ILLINOIS ENVIRONMENTAL PROTECTION AGENCY

August 5, 2010

Re: 1191150002 -- Madison County
Equilon
ILD080012305
Log No. B-43-CA-16; B-43-CA-18
RCRA Permit
Permit CA

This is in response to three submittals made on your behalf by Robert B. Billman, URS regarding an investigation being conducted along the west property line of the North property of the WRB Refining, LLC Wood River Refinery in Roxana, Illinois and the area immediately west of the refinery's North Property. The Equilon Enterprises facility which is the subject of this letter has been assigned Illinois EPA Identification Number 1191150002. This facility is physically located at the WRB Refining, LLC Wood River Refinery in Roxana, Illinois; the Illinois EPA Identification Number for the refinery is 1190905013. Equilon Enterprises is the operator for Site Number 1191150002 as it has contractual responsibilities to carry out certain remedial activities at the refinery, including those required by a RCRA permit (Log No. B-43 and associated modifications); Equilon and its corporate predecessors actually owned and operated the refinery until 2000.

SHELL OIL PRODUCTS U.S. DISSOLVED PHASE GROUNDWATER INVESTIGATION AND P-60 FREE PHASE PRODUCT DELINEATION ROXANA, ILLINOIS		PROJECT NO. 21562175
URS		
DRN. BY: dob 9/09/09 DSGN. BY: tjc CHKD. BY:	Proposed Monitoring Well Locations	FIG. NO. 1

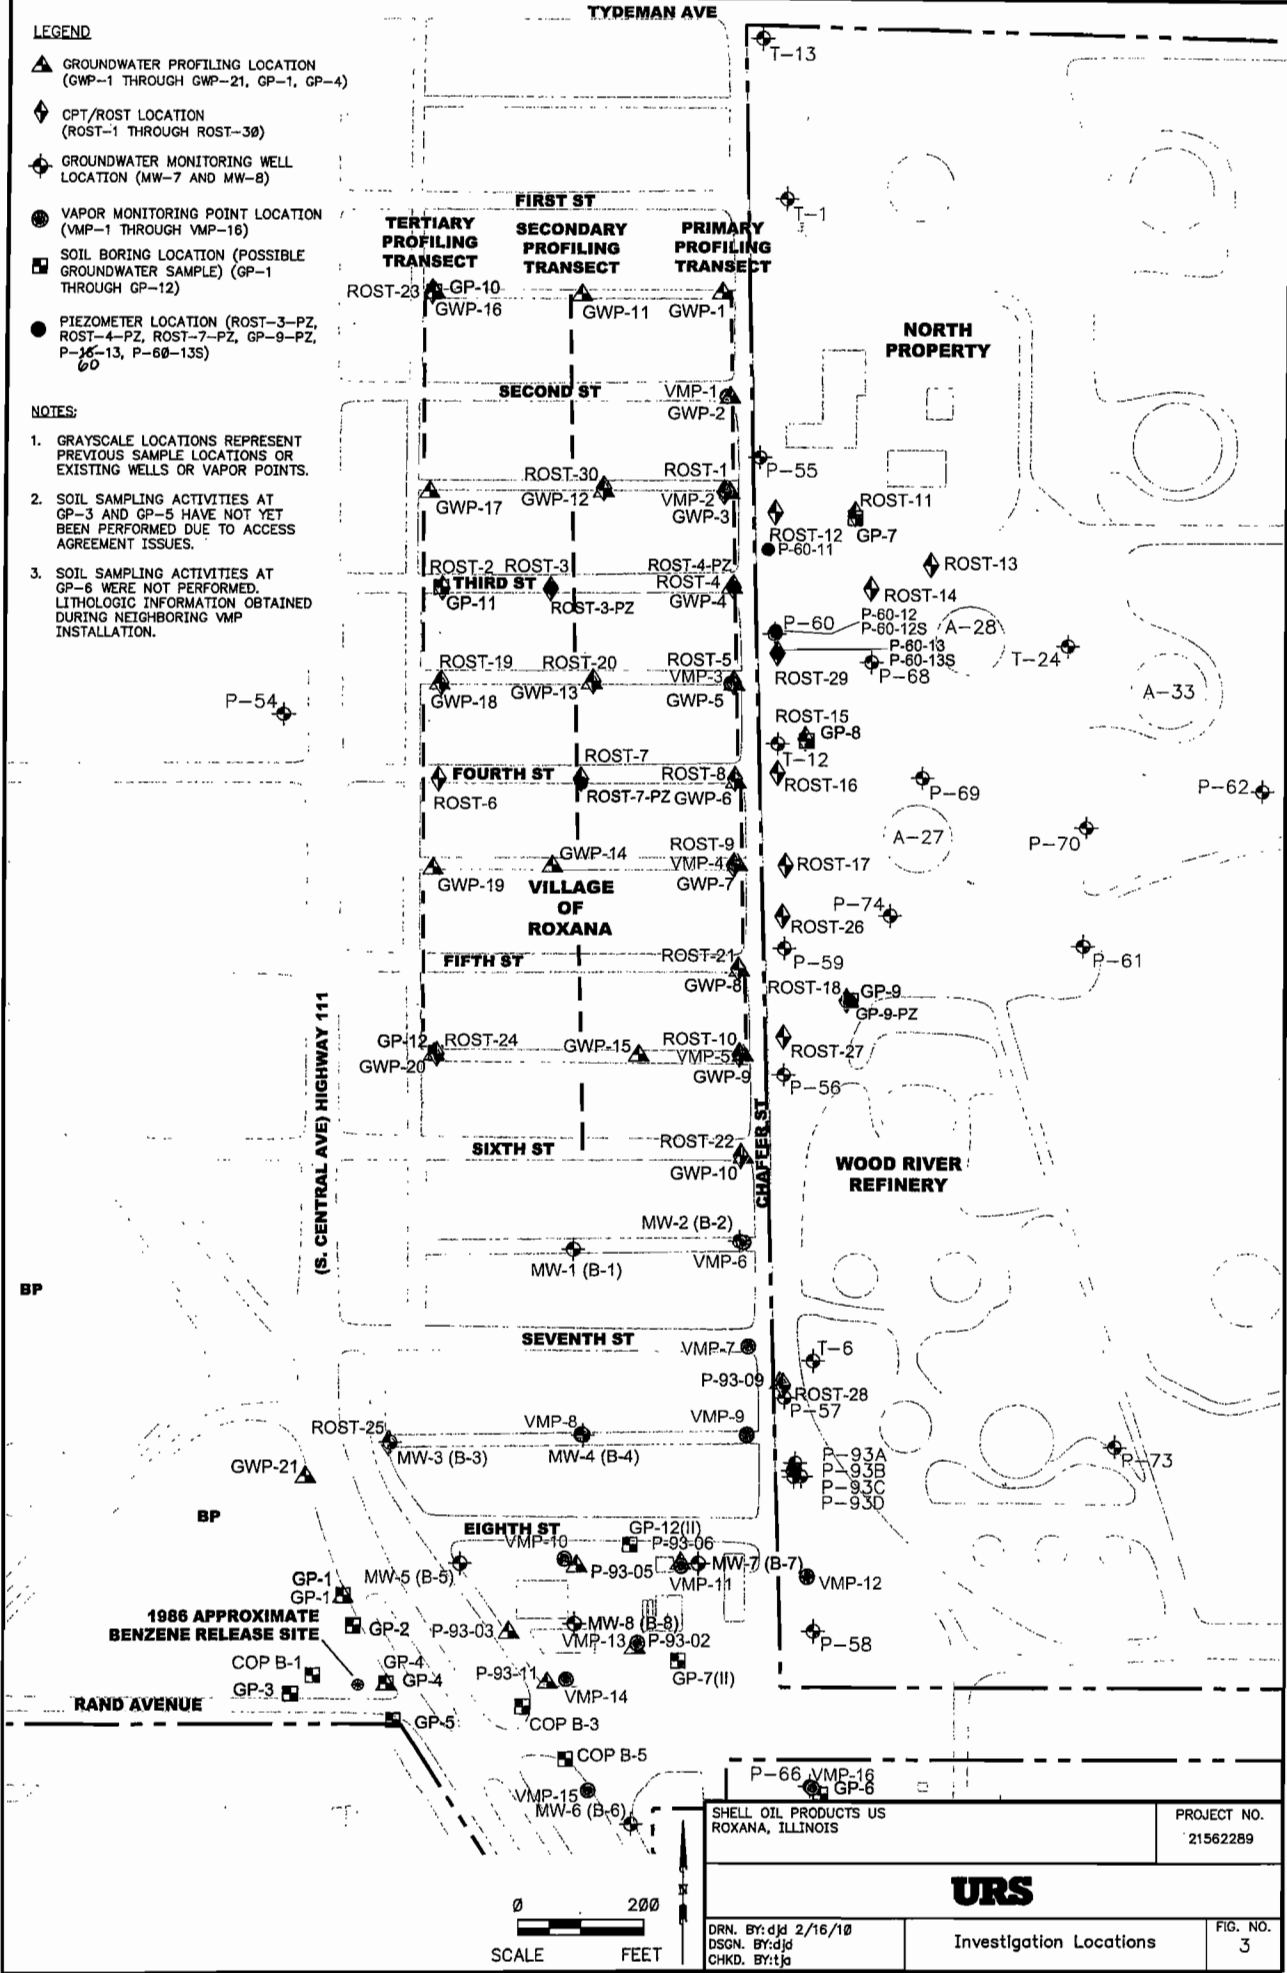
- a. Existing monitoring wells MW-1 through MW-8, P-54, and nested wells P-93-A through D;
 - b. The Illinois EPA can approve the request to install monitoring wells at the four (4) locations proposed in the September 16, 2008 document. See Attachment A to this letter for a figure depicting the approximate locations of the proposed wells. See Attachment B to the letter for the location of wells MW-1 through MW-8, P-54, and P-93A through P-93D.

- c. The facility must install the four (4) proposed wells, required by Condition 7.b above, within 45 days of the date of this letter, in accordance with well installation requirements listed in the RCRA Part B Permit. The screened interval for these wells must be installed at a depth capable of monitoring the plumes identified in the groundwater profiling investigation. Screens must be limited to a maximum of 10 feet.
